PRODUCT NOTICE

SERIES 3000/XNX REMOTE MOUNT KIT
Change of Terminal Box

Figure 1 - Dimensional Differences of Terminal Box

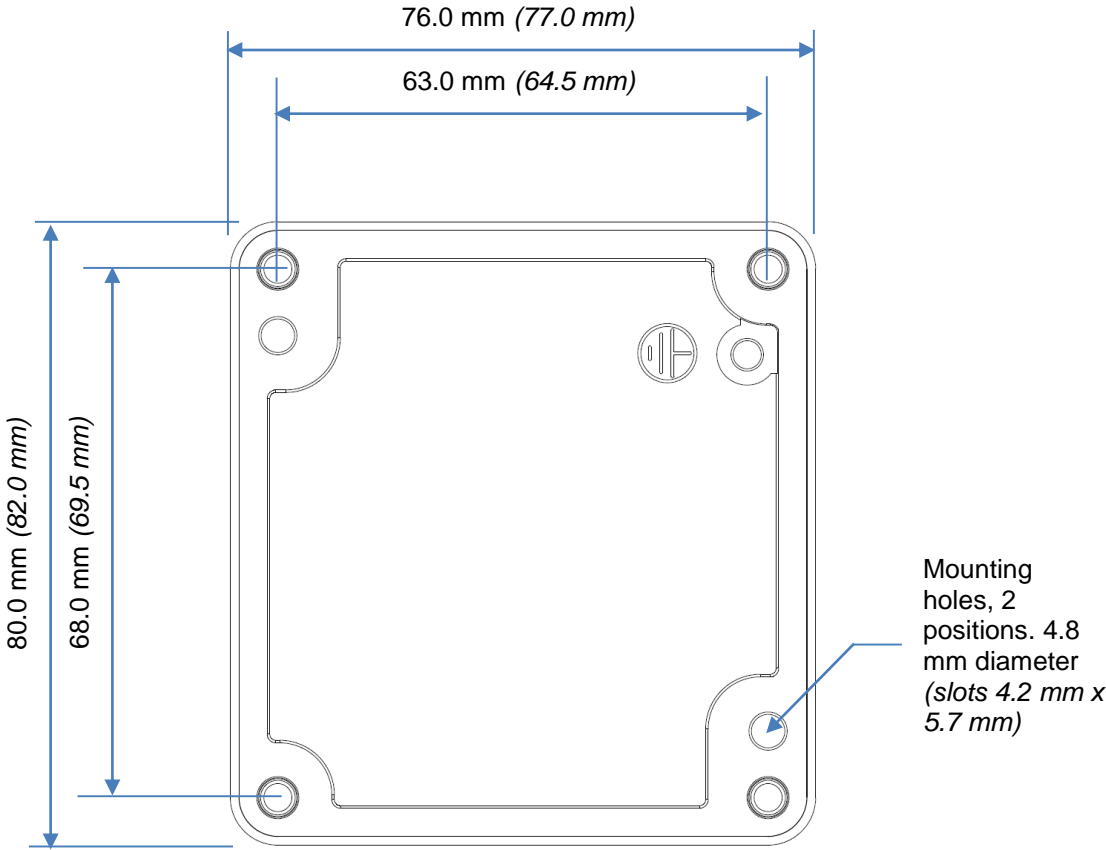
We have been informed of a failure in the tool used to produce the die-cast terminal box and as a result we will be producing this kit utilizing an alternative terminal box. This is effective immediately.

The alternative terminal box will be of identical material and construction. However there are some minor dimensional differences between the old and new parts. The detailed dimensional differences between the existing and replacement boxes are shown in the diagram below where the original dimension is shown in *italics*.
